ADDENDUM NUMBER: One

ADDENDUM NUMBER: Two

PROJECT: Government of Canada Driver Training Building Regina, Saskatchewan	ADDENDUM NUMBER: M-2
PROJECT NO : 05.004.C	DATE : June 17, 2016

PROJECT: Government of Canada Driver Training Building Regina, Saskatchewan	ADDENDUM NUMBER: M-3
PROJECT NO : 05.004.C	DATE : June 20, 2016

Drawing No.
Msk-10
Rev :

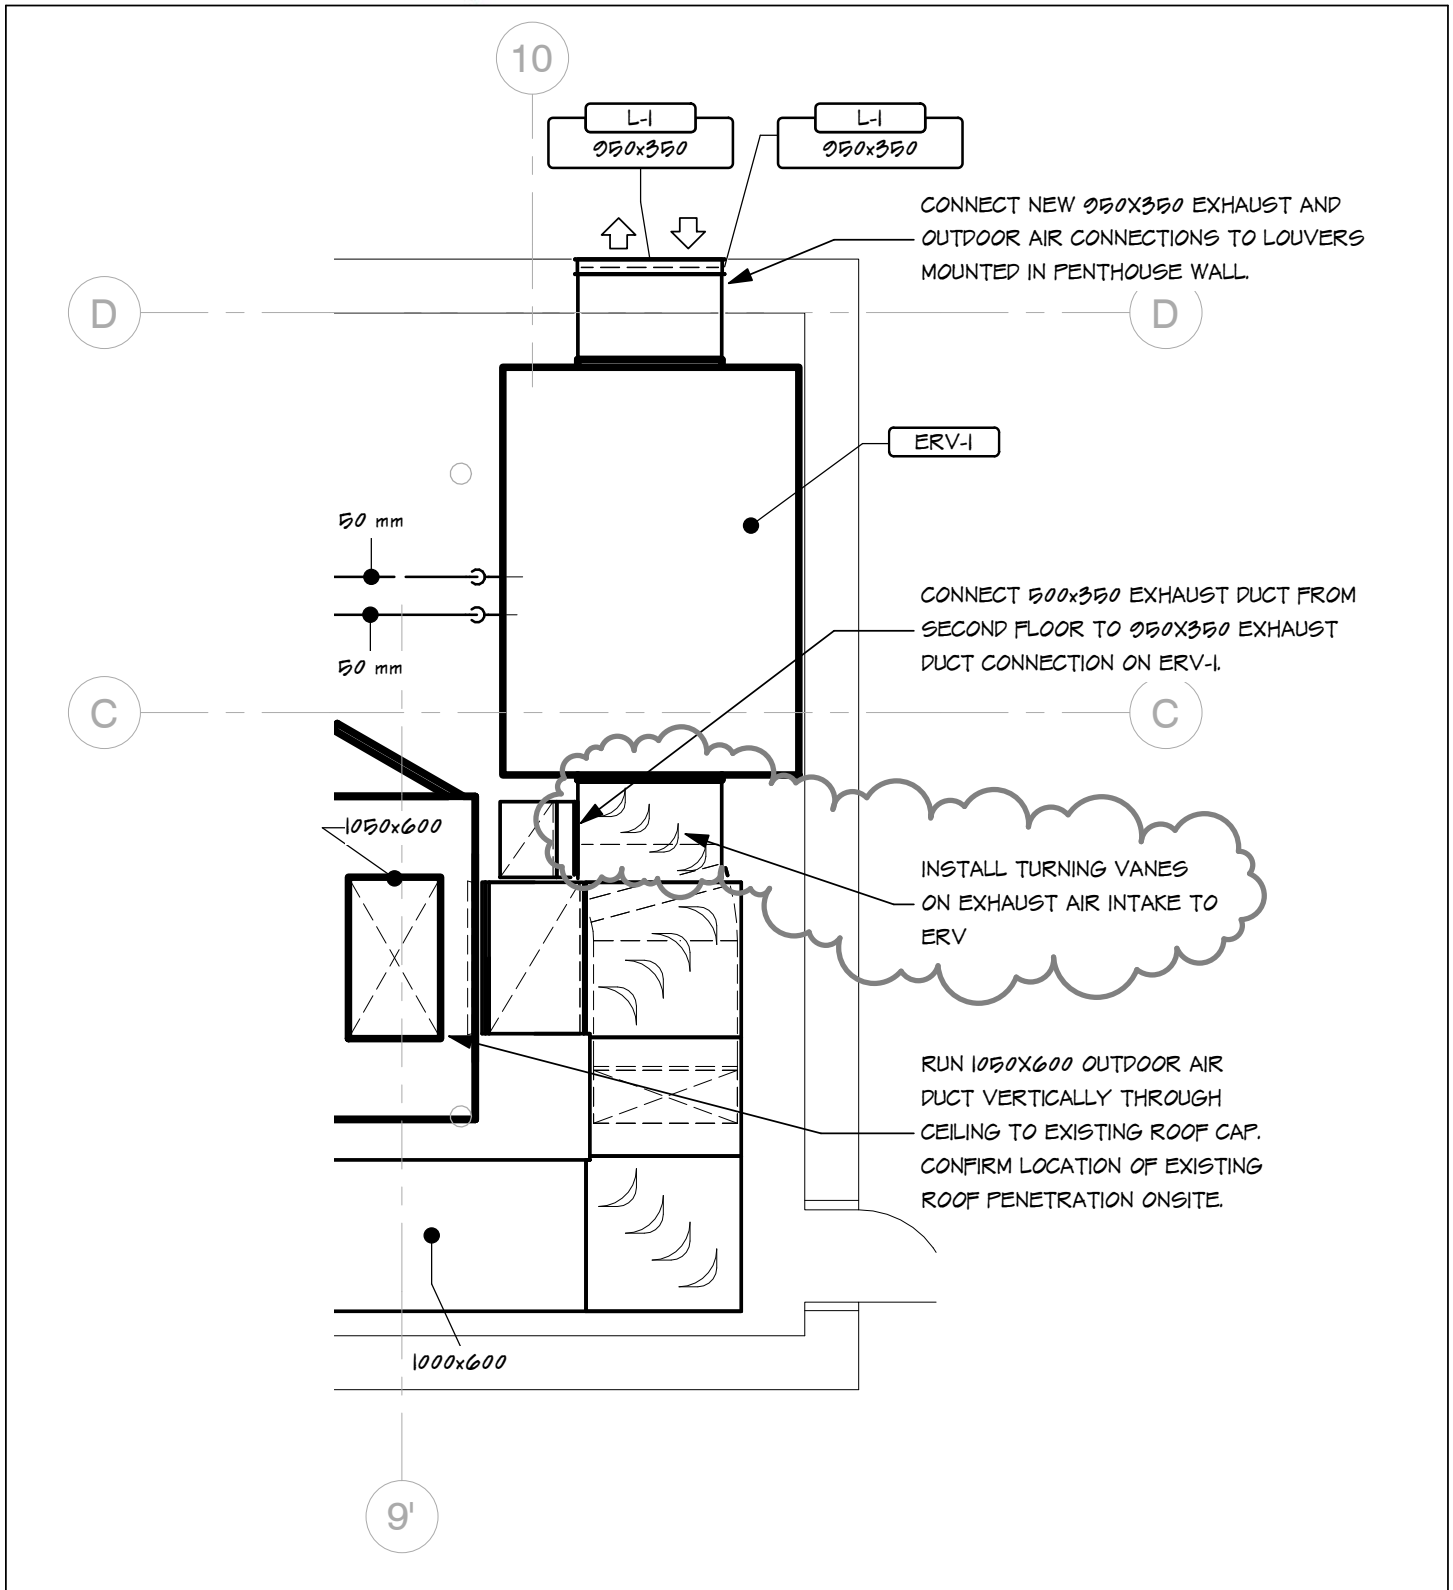
- .1 Refer to drawing M4.1 detail 1/M4.1 "New Basement HVAC" : Revise the ductwork as shown on drawings Msk-06, Msk-07, and Msk-08, all dated 2016.06.20, and issued with this addendum.
- .2 Refer to drawing M4.1 detail 2/M4.1 "New Main Floor HVAC" : Revise the ductwork as shown on drawings Msk-09, dated 2016.06.20, and issued with this addendum.
- .3 Refer to drawing M4.2 detail 1/M4.2 "New Second Floor HVAC" : Revise the ductwork as shown on drawings Msk-10, dated 2016.06.20, and issued with this addendum.
- .4 Refer to drawing M4.2 detail 2/M4.2 "New Penthouse Mechanical Room" : Revise the ductwork as shown on drawings Msk-11, dated 2016.06.20, and issued with this addendum.
